***RE: Grading and Drainage Certification Plan for Shadow Mountain Subdivision
(K21/D3B) Submitted for Release of Financial Guarantees, Engineer's Certification
Stamp Dated 10/12/99.***

**RE: Revised Grading and Drainage Plan for Shadow Mountain Subdivision (K21/D3B)
Submitted for Preliminary Plat Approval, Engineer's Stamp Dated 1/21/99.**

RE: *Grading and Drainage Plan for Shadow Mountain Subdivision (K21/D3B) Submitted for Preliminary Plat Approval, Engineer's Stamp Dated 10/27/98.*

PRELIMINARY GRADING AND DRAINAGE PLAN FOR SHADOW MOUNTAIN

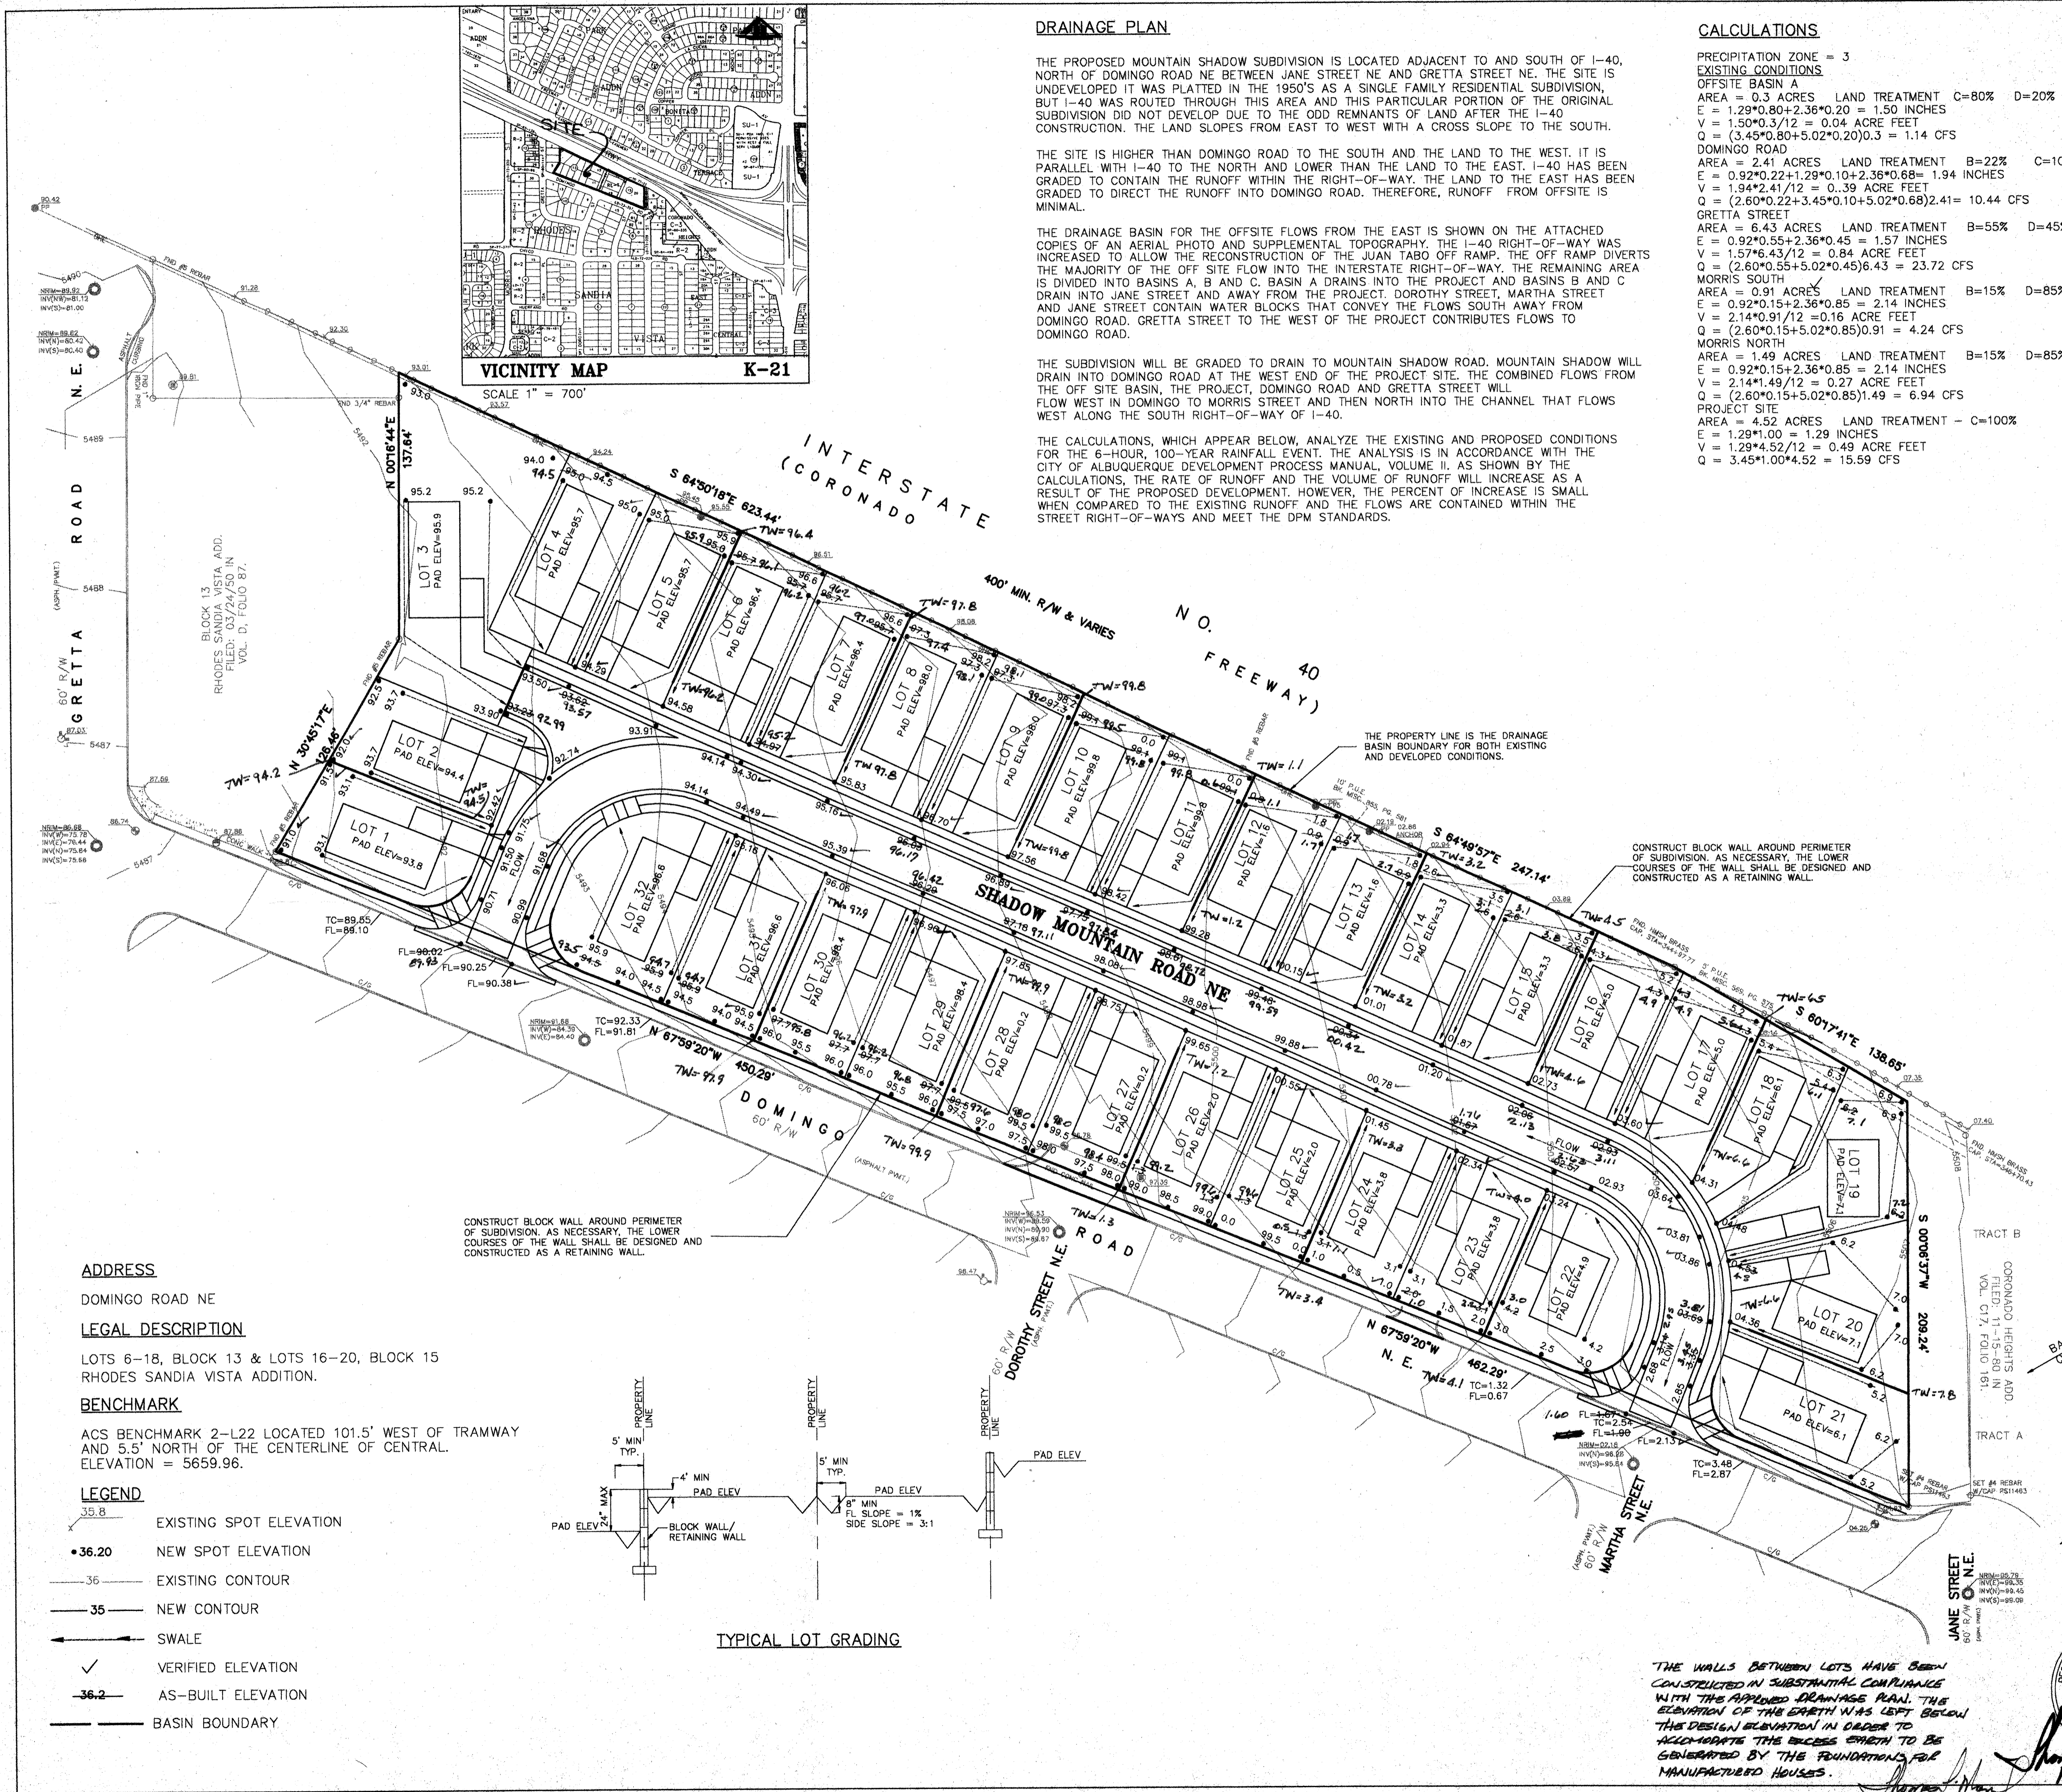
As the engineer, you must determine whether the block walls are retaining walls or not. All retaining walls must be shown on the grading plan that is approved by the DRB. Unless this plan is revised and resubmitted to City Hydrology and the DRB, the retaining walls shown by the darker lines on this plan must be certified.

1. After careful examination of the grading plan, it appears that retaining walls are needed to absorb the differences in elevations between some of the Lots. Also, provide a section for the typical Lot grading detail to show the proposed slopes on the side yards.
2. It appears by the topography provided that retaining walls are also needed along the east and west property lines.
3. Lots 24 - 33 must be revised to drain toward the front of the Lots, i.e., to Shadow Mountain Road.
4. An off-site drainage easement is required for the proposed ditch shown to the east of the site. The Quitclaim Deed is not acceptable in lieu of this document. Also show elevations along this ditch on the plan.
5. As requested in my previous comments, please show the locations of each street cross-section on the plan.

1. You state that the off-site flows from Basin A will be conveyed to Domingo Road by a proposed ditch. This ditch must be designed and be on the Infrastructure List. An off-site easement will also be required. Please provide a section for this ditch. Does Domingo have curb and gutter on the north side? Is a sidewalk culvert required?

2. The off-site drainage basin map does not show the north edge of the basin boundaries. Does the area north of the fence line drain to the north? This is not clear. The plan must show the on-site and Domingo road drainage basin boundaries.

3. The street capacity calculations are not complete. What is the depth of flow for the developed runoff at each section? You may wish to plot the 100-year water surface and EGL on each section. Show the location of the cross-sections on the plan. The sections do not include the elevations to the right-of-way. Is the EGL contained within the right-of-way on Domingo and Morris?

1. The plan states that the off-site basin to the east drains to Domingo Road, however, the contours on the maps show that these lots drain to the west which may impact this subdivision.

2. Please provide a better off-site drainage basin map with current contours. The basin boundaries must be clearly delineated.
3. The runoff calculations for the off-site basin use only 24% land treatment "D." Is this for the fully developed condition? Why does the Domingo Road basin have only 68% land treatment "D?"

4. Provide cross-sections for the streets with the capacity calculations. Since the energy grade lines overtop the curbs on some of the streets, provide elevations for the adjacent lots to show that the existing residences will not be adversely impacted by the street flow.

5. Provide the proposed street grades for Shadow Mountain Road. Where the street flows go over the curbs, will the proposed residences be impacted?
6. Provide an analysis for the 90° turn at Domingo and Morris. It appears that this water will jump over the west curb in Morris onto the Lenkurt Site.

1. Downstream capacity was not fully addressed. Your plan proposes that the runoff will go west on Domingo, then turn north on Morris. Please analyze how the water makes this 90° turn. Does any runoff from Gretta join these flows at the Domingo/Morris intersection? Is a storm drain required in Morris? After the runoff reaches the north end of Morris, where does it go? It is not clear how this runoff enters the existing channel on the Lenkurt Site. The capacity and stability of this channel must be examined. It appears that the Lenkurt Site is proposing a storm drain system in the near future. You may wish to contact Tom Isaacson regarding the design and status of this proposed system. If your subdivision develops before that system goes in, will interim improvements be proposed?

4. A complete Grading and drainage plan is required. The plan must show all existing and proposed street grades. Spot elevations, as well as pad elevations, must be provided on each Lot. If any retaining walls are proposed, these must be shown on the plan. Provide a typical lot layout to demonstrate that cross-lot drainage is not proposed. Also show the existing contours adjacent to the subdivision on the north side.

5. It appears that 17.66 cfs exits Shadow Mountain Road onto Domingo Road. Since this water will probably jump over the crown in Domingo, is there an existing standard curb on the south side of the street to prevent this water from entering private property?

CONSTRUCT BLOCK WALL AROUND PERIMETER OF SUBDIVISION, AS NECESSARY, THE LOWER COURSES OF THE WALL SHALL BE DESIGNED AND CONSTRUCTED AS A RETAINING WALL.

THE WALLS BETWEEN LOTS HAVE BEEN CONSTRUCTED IN SUBSTANTIAL COMPLIANCE WITH THE APPROVED DRAINAGE PLAN. THE ELEVATION OF THE EARTH WAS LEFT BELOW THE DESIGN ELEVATION IN ORDER TO ACCOMMODATE THE EXCESS EARTH TO BE GENERATED BY THE FOUNDATIONS FOR MANUFACTURED HOUSES.
